Site Plan Application  
Maurer's Addition  
Plan Commission, 1/21/2019

BELLA GOOSE COFFEE HOUSE AT  
 MAURER'S MARKET  
 WISCONSIN DELLS, WI

FLOOR PLAN  
 DRAWN BY  
 bk  
 DATE  
 12-29-2018  
 PROJECT  
 18-10781  
 SHEET  
**A101**

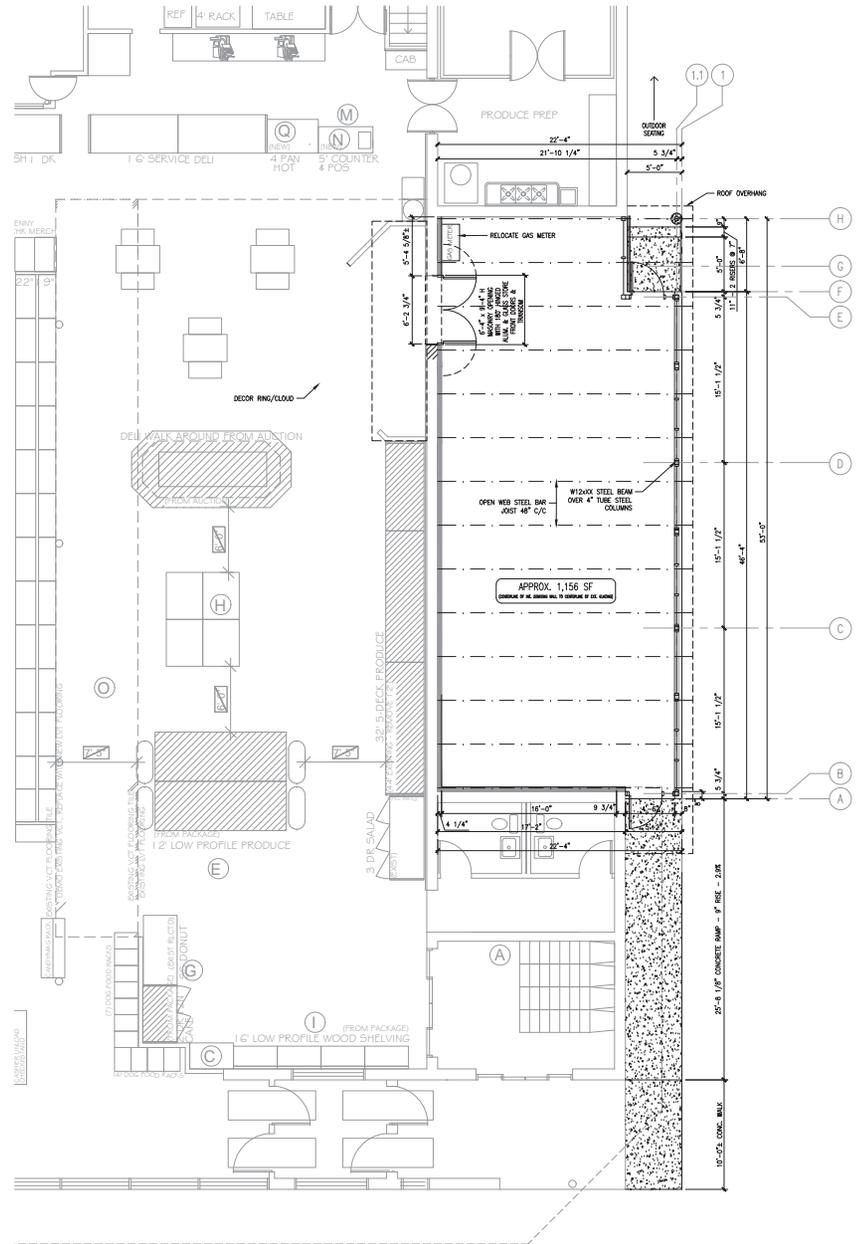
The proposed addition seems like a nice fit to this facility. The only item that raises any questions would be the loss of three (3) parking stalls. This facility is located in the C-2 Commercial-downtown Zoning District, which is exempt from any parking requirements. After a preliminary review, the Zoning code would require approximately 71 parking stalls for the expanded facility.

After the addition, it appears there will be about 40 private parking stalls on this site. There are about 18 on-street angle stalls on the south side of Washington Ave. and about 14 on-street parking stalls on the north side of Washington Ave. There are also 5 on-street parking stalls on the east side of Superior St. So with the loss of the 2 parking stalls, there would be 33 private stalls and 37 public stalls, for about 77 parking stalls near this facility.

The applicant has stated that they are confident the available parking is adequate for their business purposes.
